# Service Bulletin

17-029

# Safety Recall: 2017 MDX Hybrid Fuel Feed and Purge Hose Mis-Installation

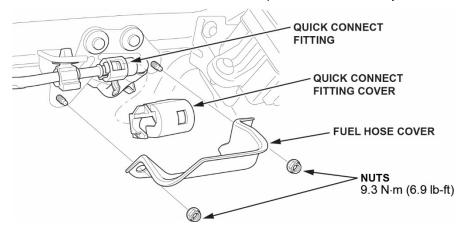
- 3. Relieve the fuel pressure using the i-HDS.
- 4. Remove the fuel hose cover.
- 5. Remove the quick connect fitting cover on the frame side, then disconnect the quick connect fuel line.

NOTE: A disconnected quick connect fitting can be reused, but the retainer on the mating line cannot be reused once it has been removed from the line. Replace the retainer only if needed.

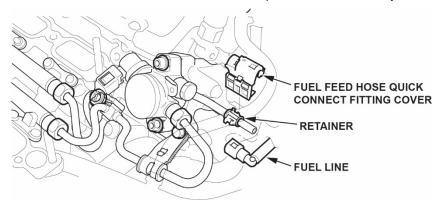
6. Remove the fuel feed hose quick connect fitting cover on the engine side, then disconnect the fuel line.

NOTE: A disconnected quick connect fitting can be reused, but the retainer on the mating line cannot be reused once it has been removed from the line. Replace the retainer only if needed.
